SALEM NUCLEAR GENERATING STATION
 NO. 1 UNIT - REACTOR CONTAINMENT
 AUXILIARY FEEDWATER
 ELEVATION 78'-0" & 100'-0"

HANGERS MECHANICAL

226129-D -0

SH. 26

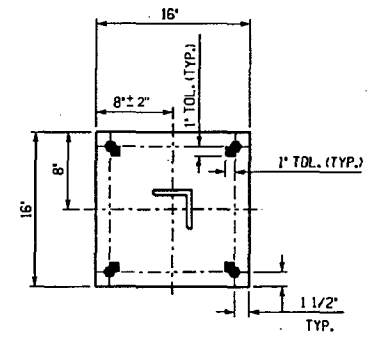
NOTE "A" - REV. B
 UPDATED/ISSUED PER DCP 80101382, AD H29R0.

80101382R2
 H29R0
 INSTALL NEW CUDE AS SHOWN

ELEVATION LOOKING SOUTH
 (ONE ASSEMBLY REQUIRED PER SUPPORT NUMBER)

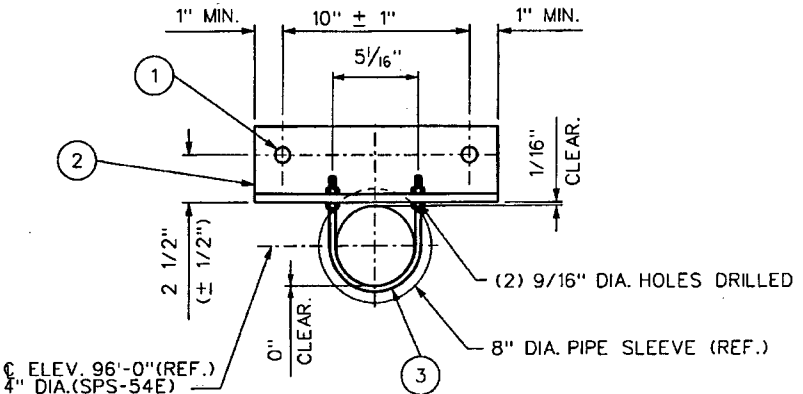
NOTE "A" - REV. 0
 UPDATED/ISSUED PER DCP 80101382, AD H36R0.

80101382R2 H36R0 INSTALL NEW GUIDE AS SHOWN				PSEG NUCLEAR L.L.C. NUCLEAR ENGINEERING	SALEM NUCLEAR GENERATING STATION NO. 1 UNIT - REACTOR CONTAINMENT AUXILIARY FEEDWATER ELEVATION 78'-0" & 100'-0"	226129-D -0
REVISION NO. DATE DESCRIPTION DWN PEER REV APD				DATE _____ DRAWN _____ CHECKED _____ EXAMINED _____	HANGERS MECHANICAL	SH. 33
